**STAFF RECOMMENDATION
316 South 11th Street
May 20, 2020**

Application: Violation; New Construction—Addition
District: Lockeland Springs-East End Neighborhood Conservation Zoning Overlay
Council District: 06
Base Zoning: R6
Map and Parcel Number: 08313008500
Applicant: Keith Whitaker, Owner
Project Lead: Sean Alexander, sean.alexander@nashville.gov

Description of Project: The applicant requests after-the fact approval of revisions to a rear addition that has been partially constructed. The addition was originally approved to match the width of the house, but the massing is to be shifted four feet (4') to the left because of a sewer easement, pushing the addition wider than the historic house on the left side.

Note: Site Plan based on Metro Maps

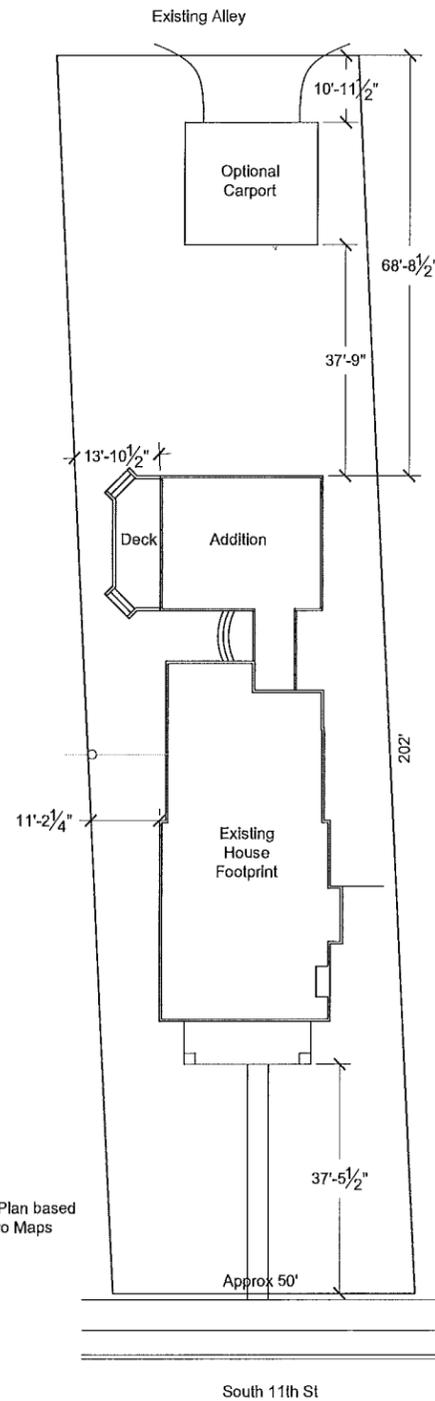
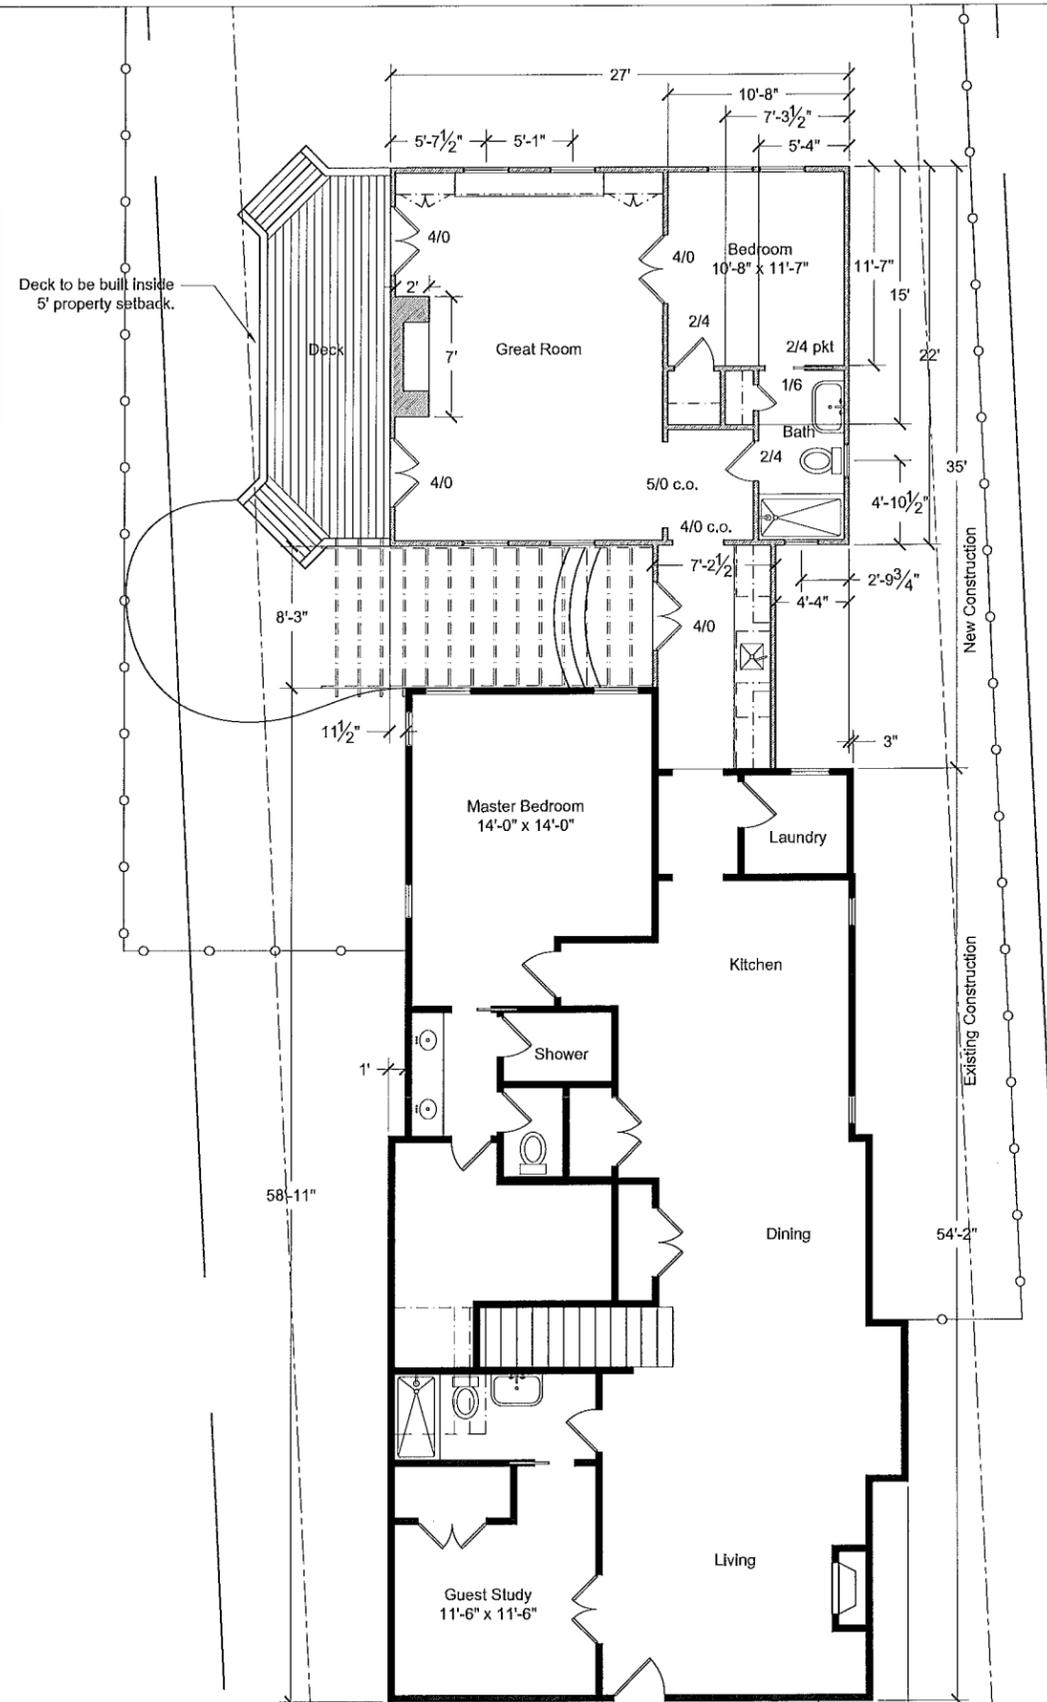
1. Please refer to notes on page 1 and 2.
2. Staff must approve the construction progress at the three following points:
 - a. After the building footprint has been field staked
 - b. After the foundation has been constructed
 - c. After the rough framing has been completed
3. Window and door selections must be submitted for final approval before purchase.

Proposed West Elevation

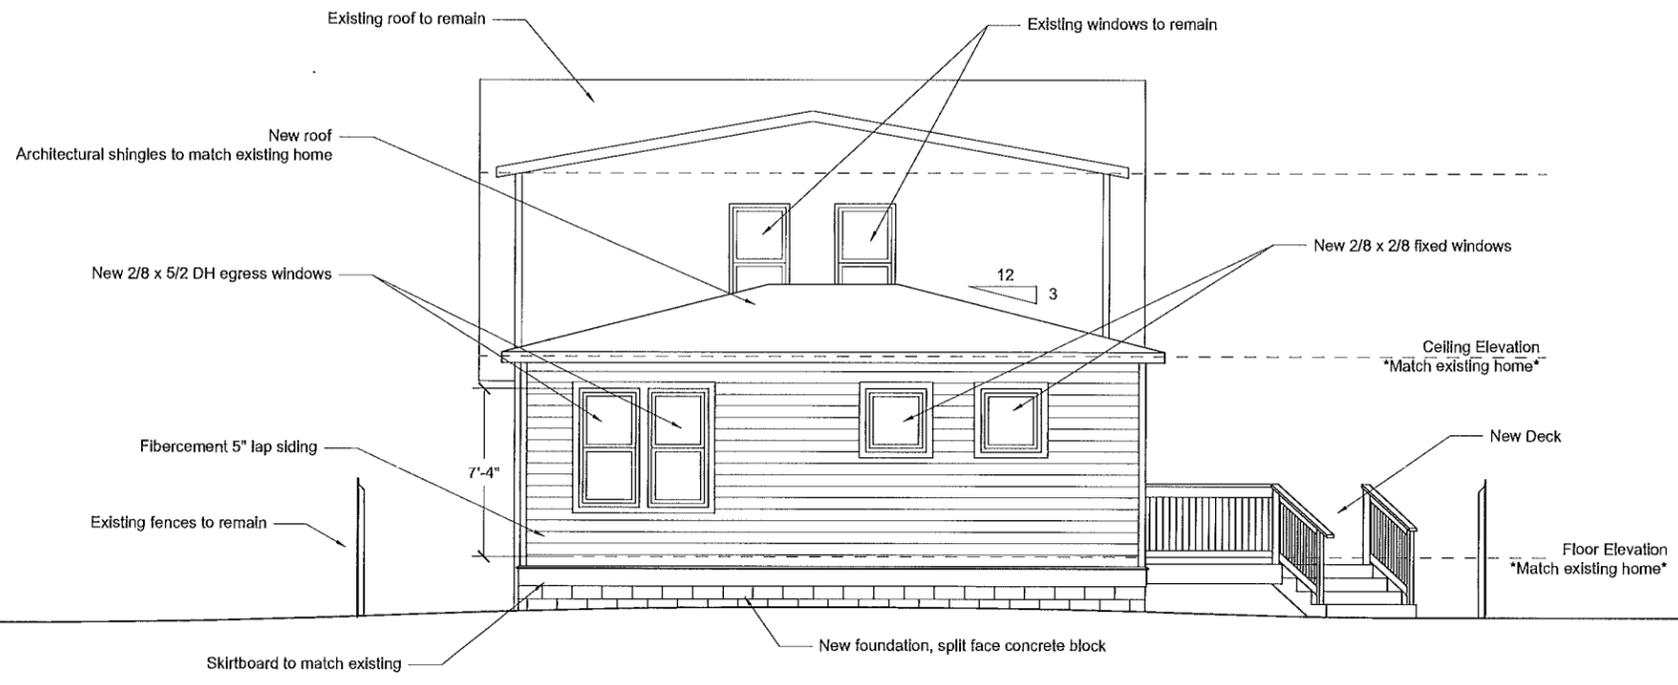
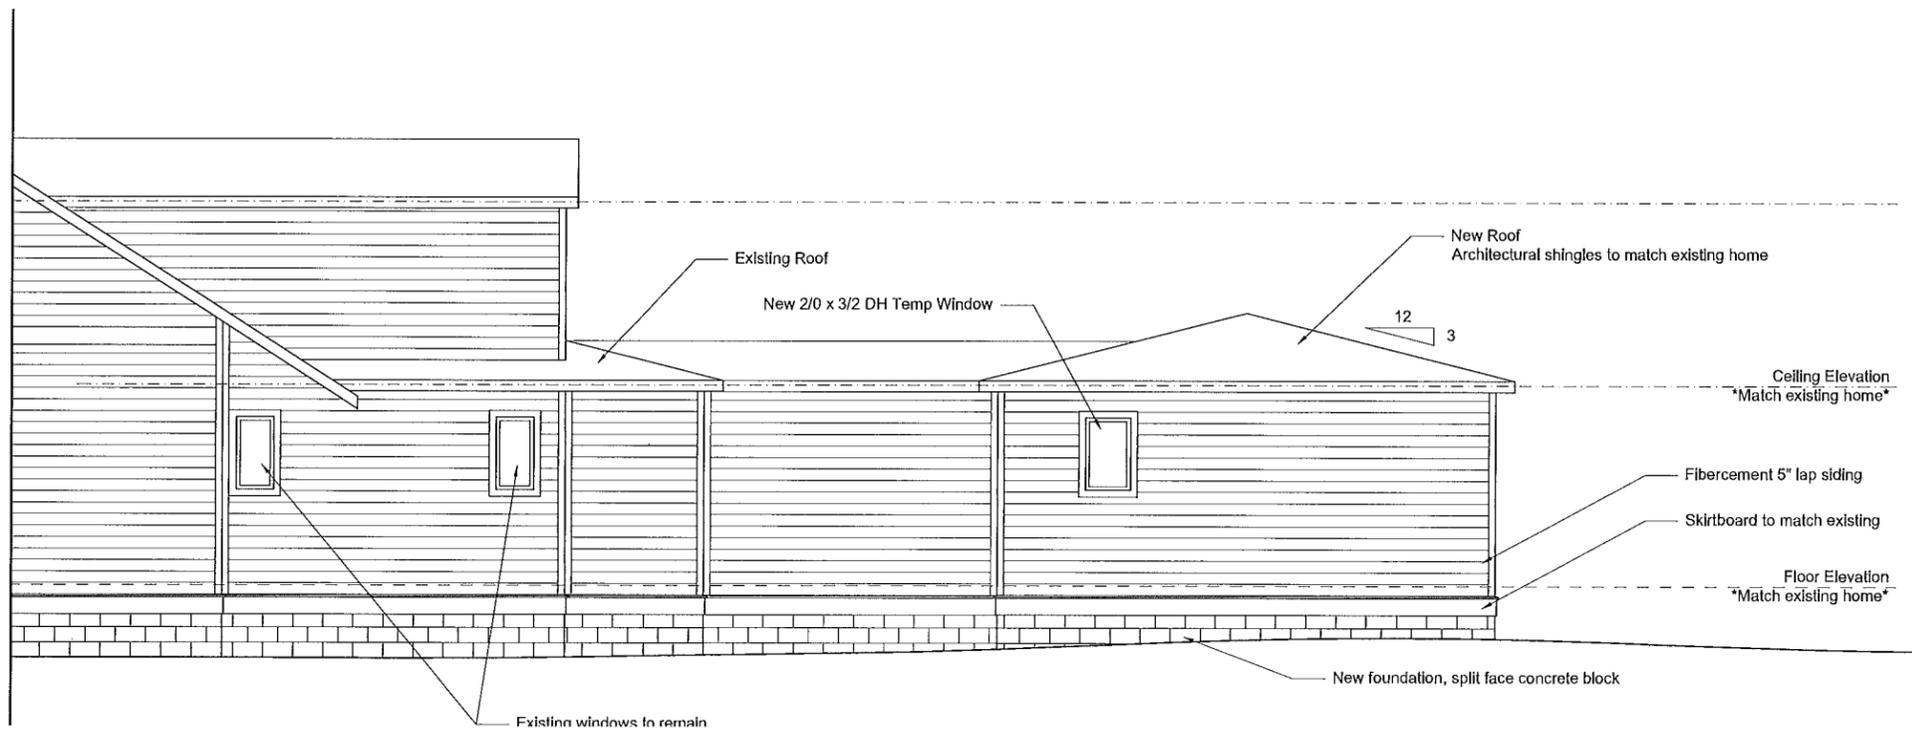
1. Please refer to notes on page 1 and 2.
2. Staff must approve the construction progress at the three following points:
 - a. After the building footprint has been field staked
 - b. After the foundation has been constructed
 - c. After the rough framing has been completed
3. Window and door selections must be submitted for final approval before purchase.

Proposed East Elevation

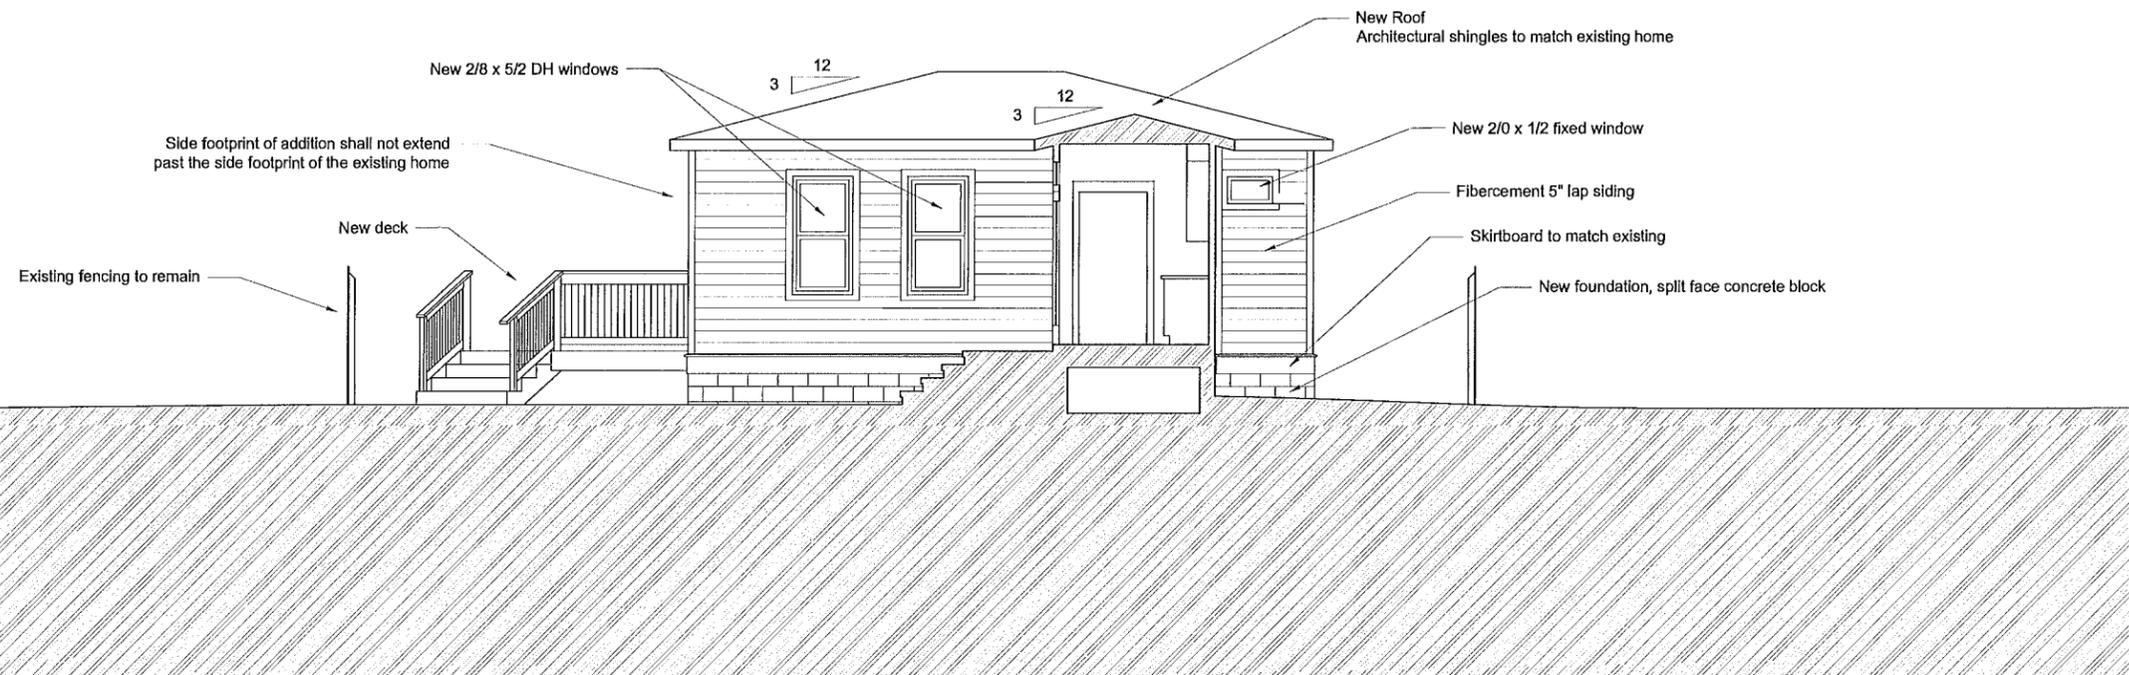
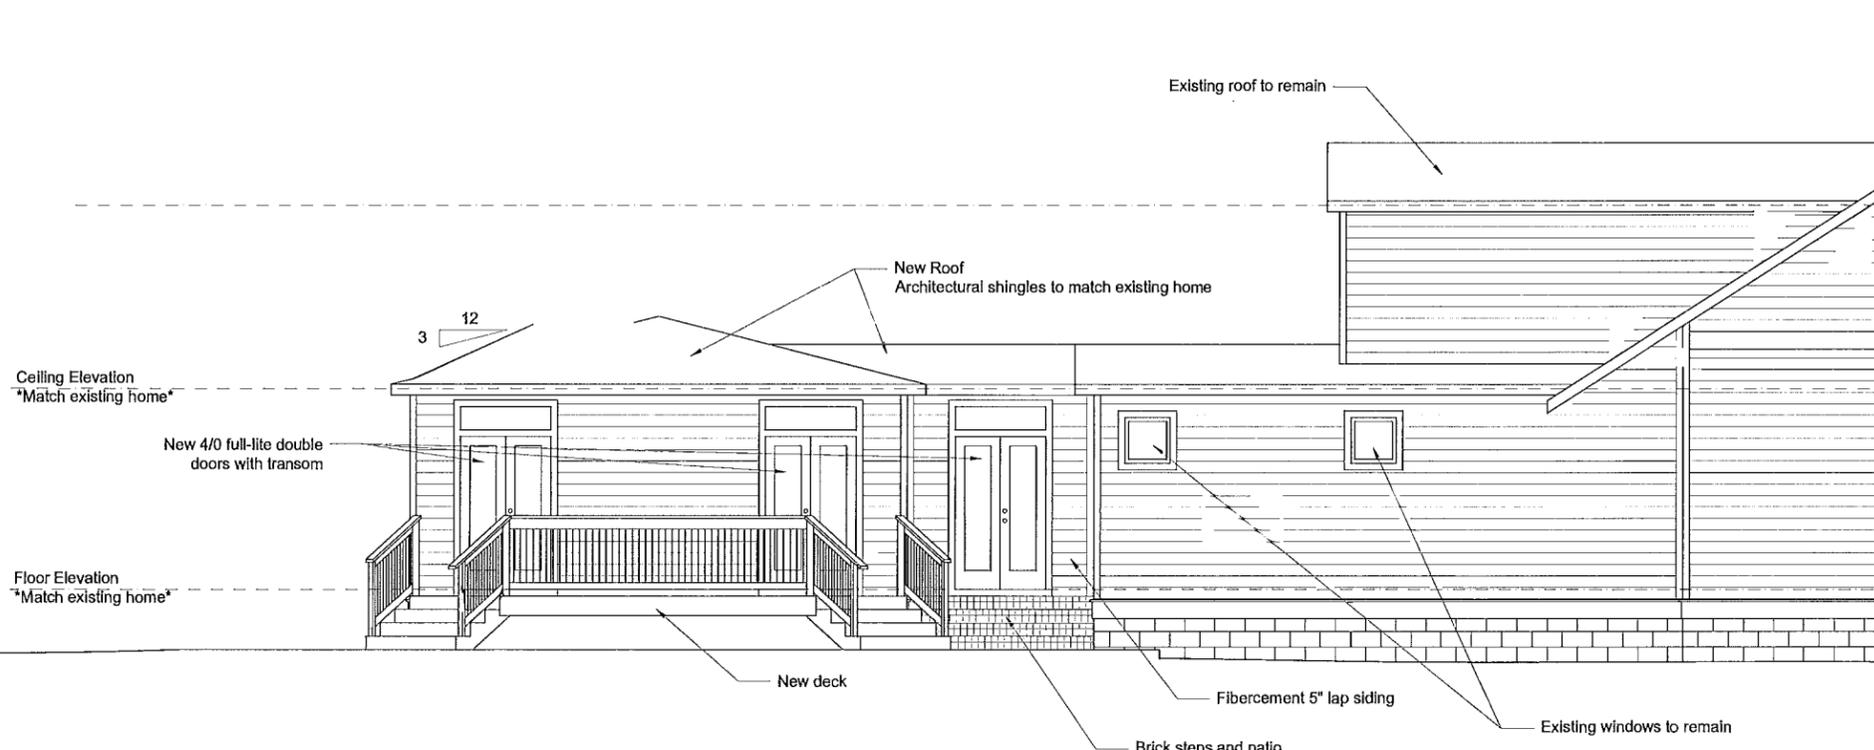
1. Please refer to notes on page 1 and 2.
2. Staff must approve the construction progress at the three following points:
 - a. After the building footprint has been field staked
 - b. After the foundation has been constructed
 - c. After the rough framing has been completed
3. Window and door selections must be submitted for final approval before purchase.

Site Plan
 316 S 11th Street
 Nashville, Davidson County, Tennessee

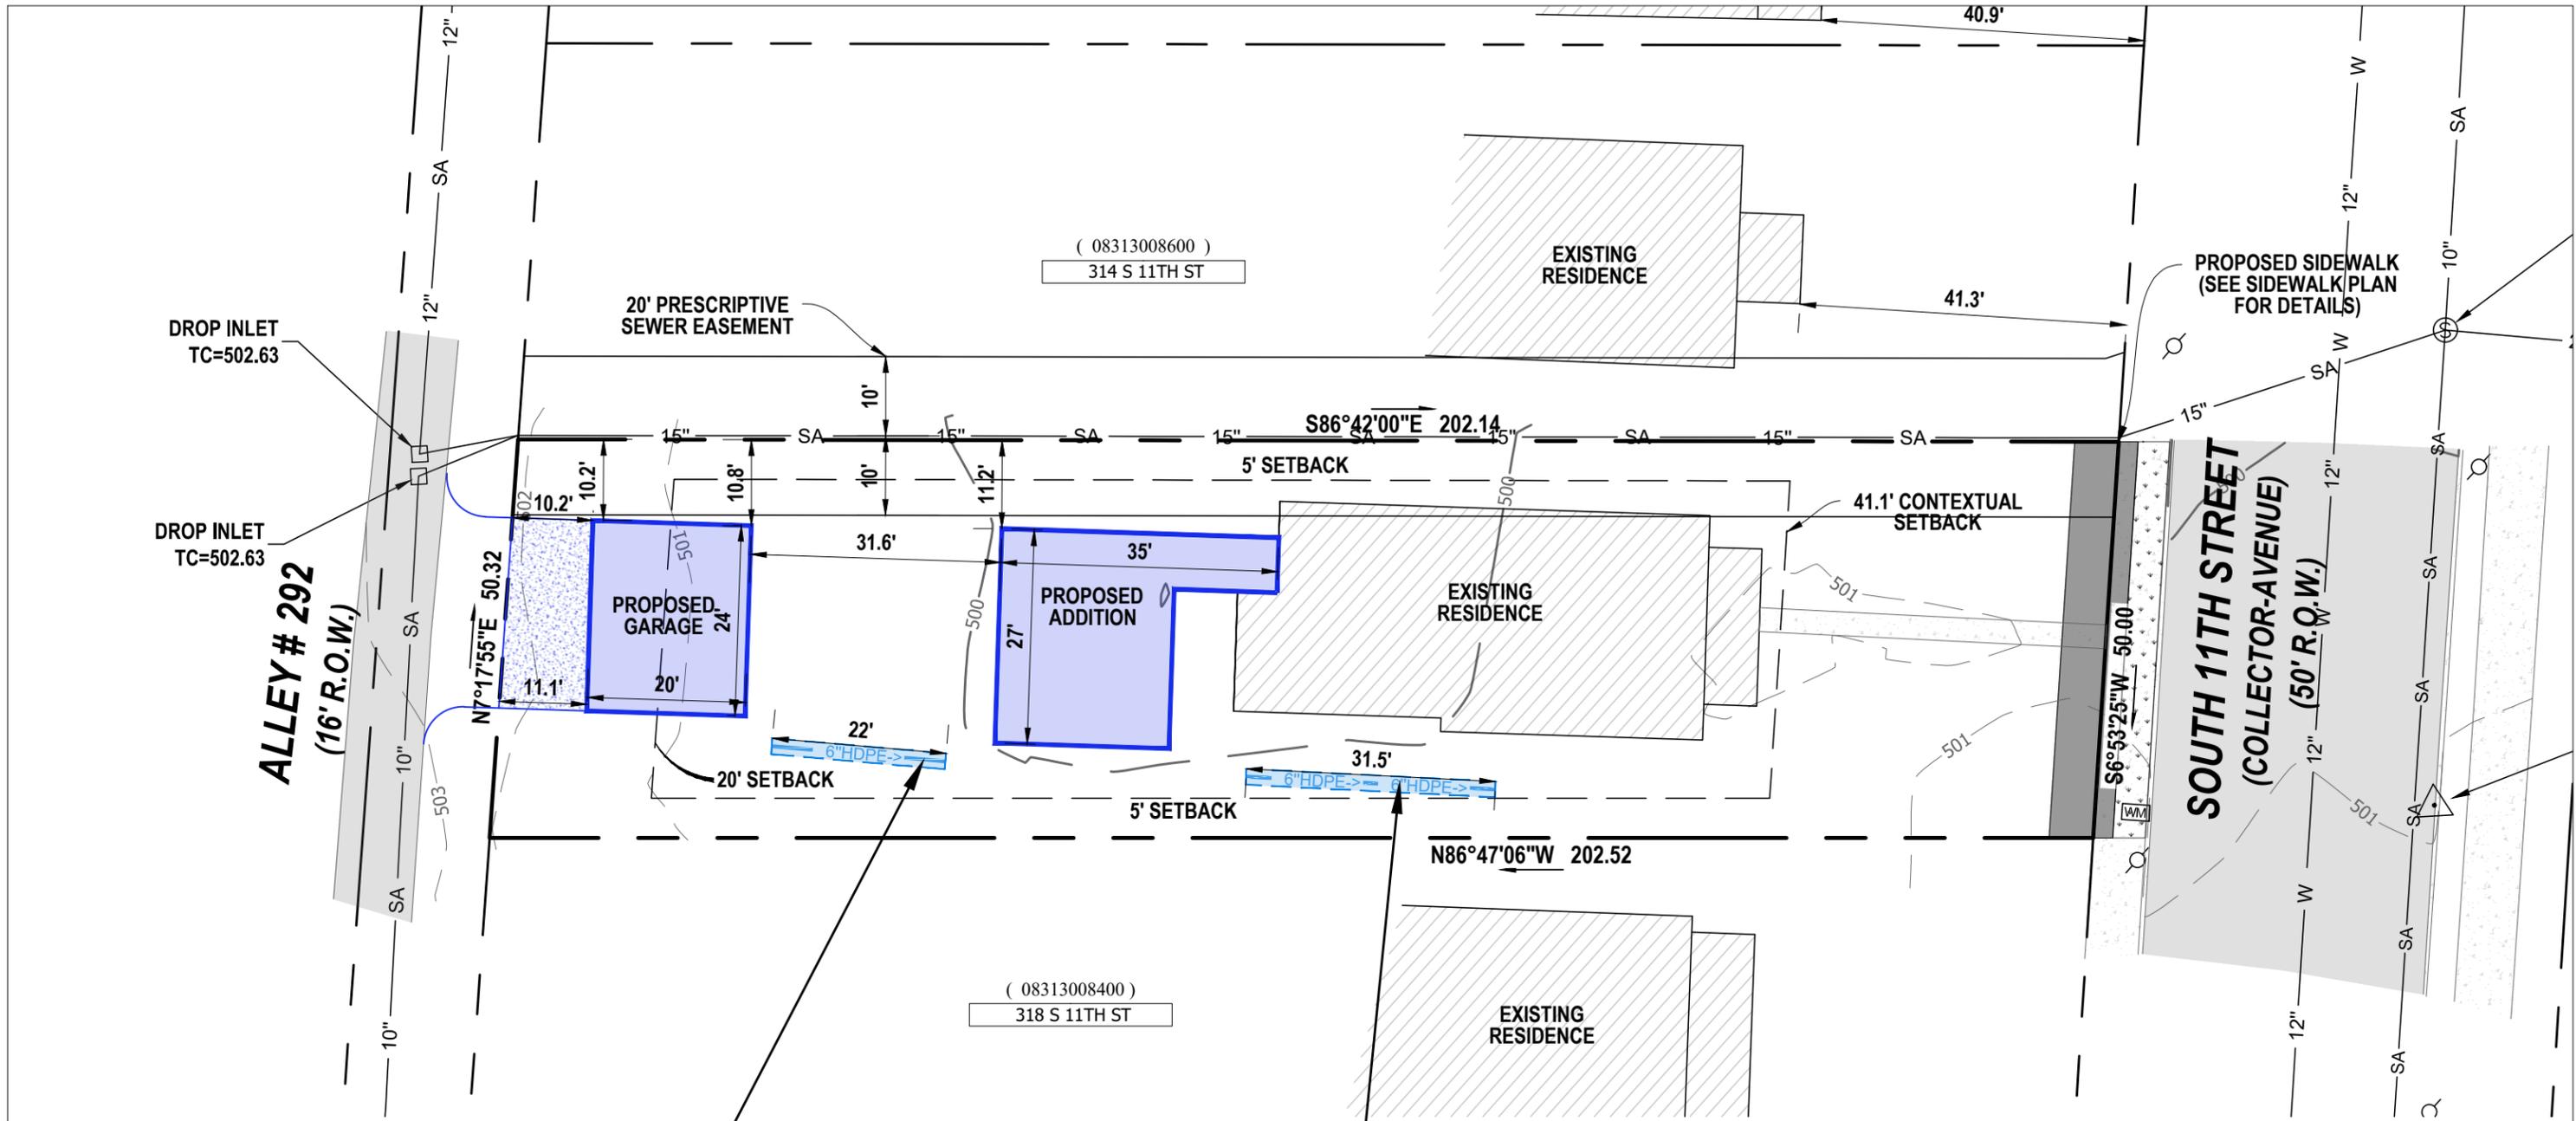
INSTALL MODIFIED FRENCH DRAIN SYSTEM
 (2' x 53.5' @ 2.5' LOWER STONE DEPTH)
 DIVERT ALL GARAGE AND ADDITION
 ROOF DRAINAGE TOWARD MFDs
